INFORMATIVE CD600

APR / 03
CD600
REV. 00

Replacement of the Front Panel and the CD600 cards

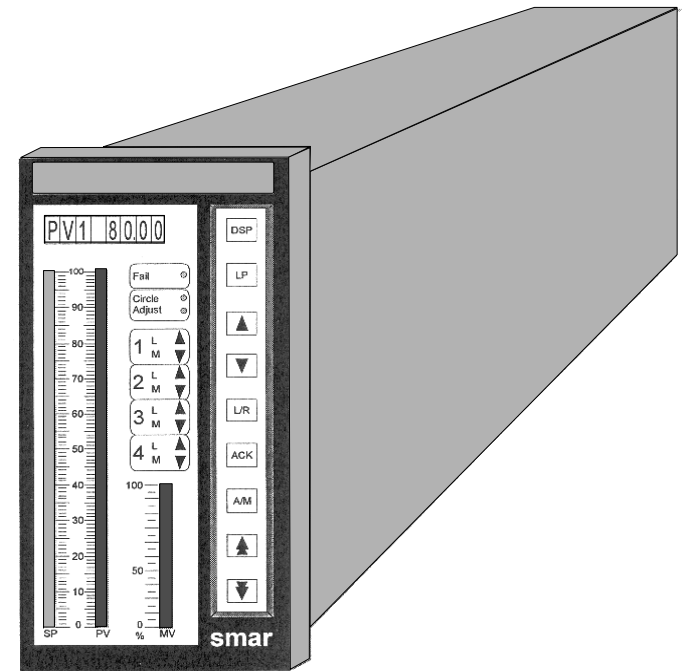
The GLL601 and GLL610 cards will be replaced by the GLL1252 and GLL1253 cards. In order for these new cards to be used, a few adaptations will be needed on the GLL600. These changes consist on the update of the firmware version from 2.02 to 3.04, and on the J2 connector, the 26th pin should be disconnected from the "A10" signal and connected to the "/RST" signal, as detailed below.

- Make sure to backup the configuration before the adaptation, because with the firmware change the configuration will be lost.
- The GLL 600 card Rev.: 05 is **already adapted**.
- This page is better seen on the web site: www.smar.com/products/cd600.asp

- "Wire Wrap"
- 2 memory chips (Firmware 3.04)
- Complete front set (ref.:400-0634)
- or
- Cards only set (ref.:400-0635)
